## COMPARTMENTALIZATION PILOT PROJECT, TANGAIL

A STUDY ON THE HYDROLOGICAL IMPACT  
ASSESSMENT OF THE JAMUNA BYPASS AND  
RAILROAD IN CPP AREA

November 1997

**Map2: Alignment of the Jamuna Bypass & Railroad through CPP area  
(with proposed structural interventions)**

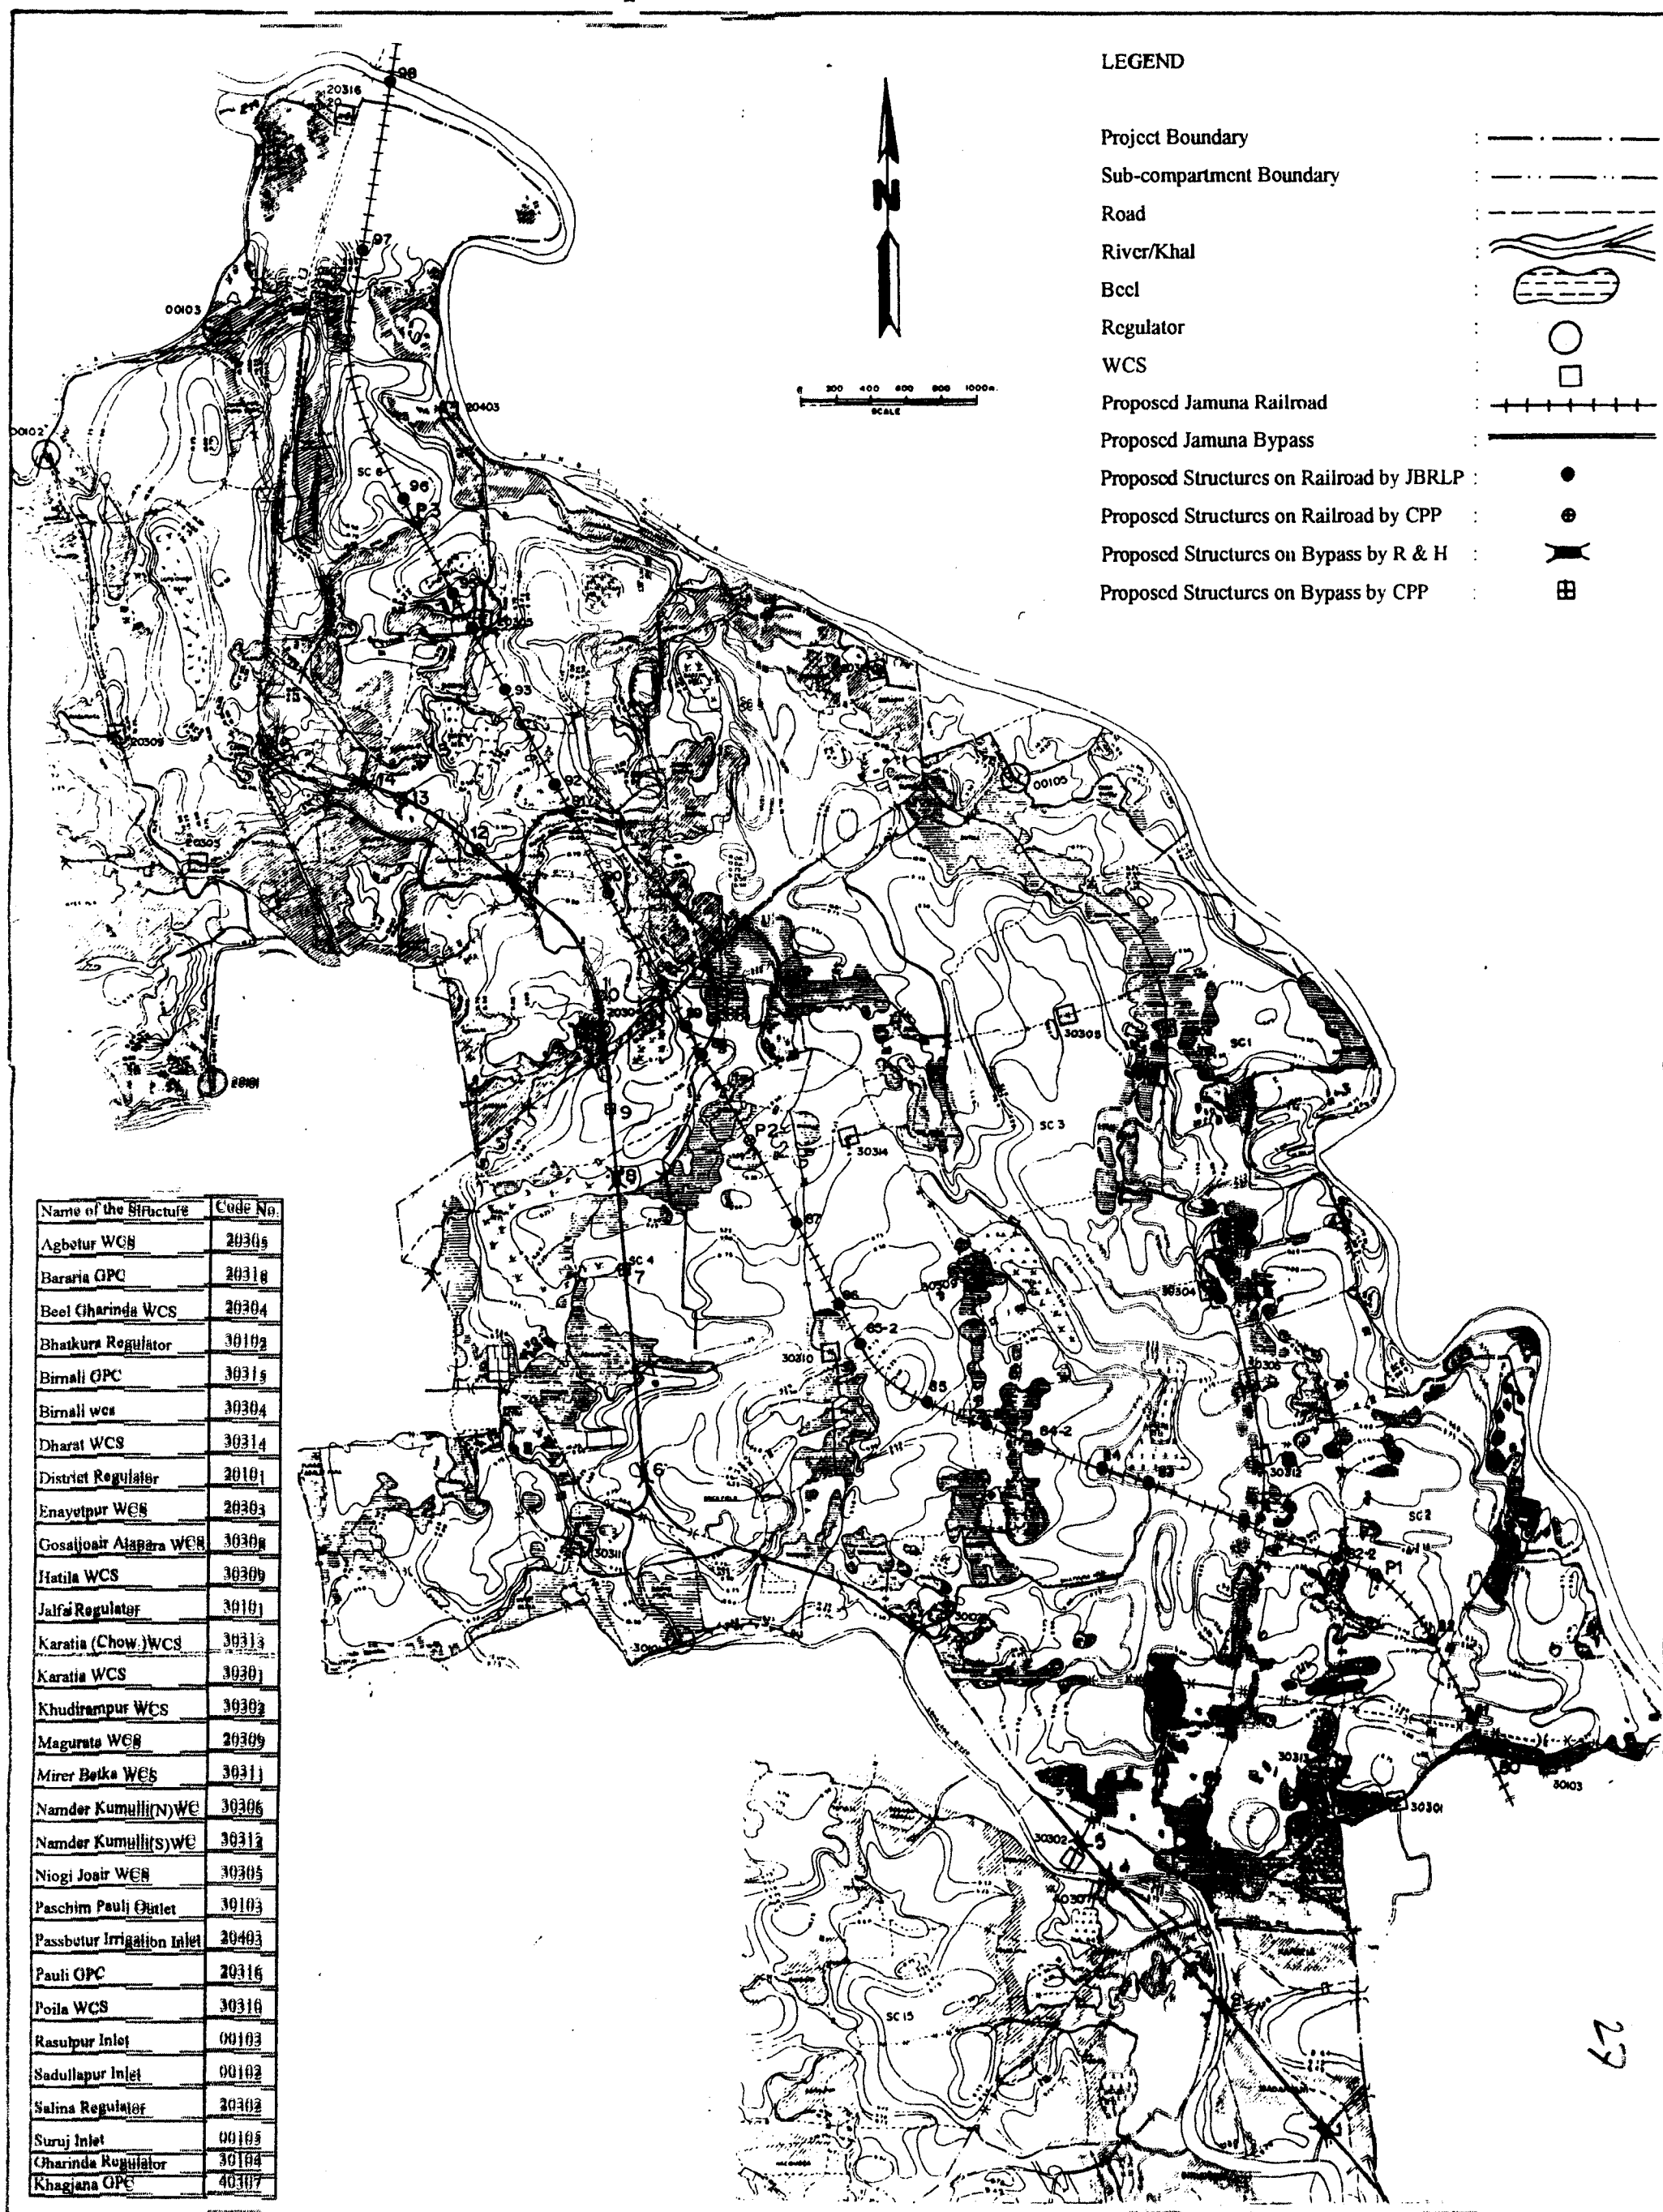
Two structures (structure no. 95 and 96) are proposed by JBRLP on the railroad alignment of this chawk. The total horizontal opening of these two structures is 86 m. The alignment crosses the Rasulpur-Agbethur khal (locally known as Tarabari khal) at chainage 65.195 km which is under implementation. The land possession has already been received by CPP for implementation of the said khal. But it is found from the supplied map (Drawing no. AL 1047, August/97) that the acquired land from ch. 60.085 km to ch. 65.240 km is 25 m more at each side of the alignment than the normal land acquisition. The Tarabari khal falls in between the said chainage where no structure was proposed. The proposed structure no. 96 is located outside the chainage mentioned. Therefore, it is necessary to relocate the structure no. 96, over Tarabari khal (ch. 65.195 km).

The northeastern part (right side of the bypass) is split into two parts by an internal road. These two parts are bounded by roads without any opening which would create water logging due to rainfall in that area. The upper part is high land where no opening is required. But in the lower part one small box culvert (2.0 m × 2.0 m) at ch. 1.60 km is required to remove water logging due to rainfall.

Only one structure at chainage 0.416 km is proposed by R & H on the alignment of Tangail bypass. The size of the opening provided is 5.00 m × 5.00 m. But the bed width of the Gharinda-Jalfai khal at that location is 7 m. Therefore the horizontal opening of the box culvert should be 7 m. Again part of the Darun beel (lower edge) is located within the upper part of this chawk. The stored water in Darun beel drains into the Gharinda-Jalfai khal, but the bypass crosses in between the Darun beel and the Gharinda-Jalfai khal. Due to that a depression near the Darun beel would be isolated and would be no longer able to drain towards the Gharinda-Jalfai khal. It is to be noted here that the storm and the sewerage water from the Tangail drain from Tangail town would be disposed to the Darun beel which would create waste water hazards in the Darun beel as well as drainage congestion. To eliminate such drainage congestion, it is necessary to provide a box culvert (5.5 m × 5.5 m) near Darun beel at chainage 1.550 km.

Only one structure at chainage 2.335 km is proposed by R & H on the alignment of Tangail bypass over the upper edge of the Darun beel. The size of the opening provided is 4.50 m × 4.00 m. But water from the Darun beel will be drained into the Gharinda-Jalfai khal through the CPP constructed box culvert whose horizontal opening is 5.5 m. Therefore the horizontal opening of the box culvert should be 5.5 m instead of 4.5 m. Again an internal

earthen road has been built across the chawk towards Sarutia village at the northern bank of the Darun beel. As a result drainage congestion will take place at the northern part of the chawk. Gharinda beel is located at the right side of the bypass. A depression connects the western side of the northern part of the chawk with the Gharinda beel. Therefore, it is necessary to provide a box culvert (4.5 m \* 4.0 m) at chainage 2.700 km for proper drainage.

Due to the bypass, an existing bridge on the Tangail-Gharinda road would be completely obsolete. The western part of the bypass would be completely encircled by roads and no opening is provided for draining towards the Gharinda beel. Therefore, the western part of the bypass should be connected with the beel Gharinda WCS for proper drainage. Based on the drainage consideration, it is necessary to provide a box culvert (5.0 m \* 5.0 m) at chainage 3.300 km.

Two structures are provided by R & H at chainages 4.008 km and 5.085 km over the Sadullahpur khal and Shibpur khal respectively in the southern and western boundary of the chawk. The land elevation of this chawk is from south to north (left to right part of the bypass). The area under the left part of the bypass would go permanent drainage congestion due to the high bank of the Sadullahpur khal and also due to the homestead as well as no opening provided over the bypass within the chawk. Therefore, to remove drainage congestion, it is required to provide two small box culvert (each 2.0 m × 2.0 m) at chainages 4.100 km and 4.830 km respectively.

Two structures (structure no. 95 and 96) are proposed by JBRLP on the railroad alignment of chawk 11D. The total horizontal opening provided of these two structures is 86 m. The alignment crosses the Rasulpur-Agbethur khal (locally known as Tarabari khal) at chainage 65.195 km which is under implementation. The land possession has already been received by CPP for implementation of the said khal. But it is found from the supplied map (Drawing no. AL 1047, August/97) that the acquired land from ch. 60.085 km to ch. 65.240 km is 25 m more at each side of the alignment than the normal land acquisition. The Tarabari khal falls in between the said chainage where no structure was proposed. The proposed structure no. 96 is located outside the chainage mentioned. Therefore, it is necessary to relocate the structure no. 96, over Rasulpur khal (Tarabari khal) at ch. 65.195 km.

Sill level (floor level) is an important factor for proper water management. Too high sill level creates water congestion which would affect the hydrology of the area and may change the water management possibilities considerably. Therefore, special attention should be paid regarding the sill levels during designing of box culverts and should be verified during execution.
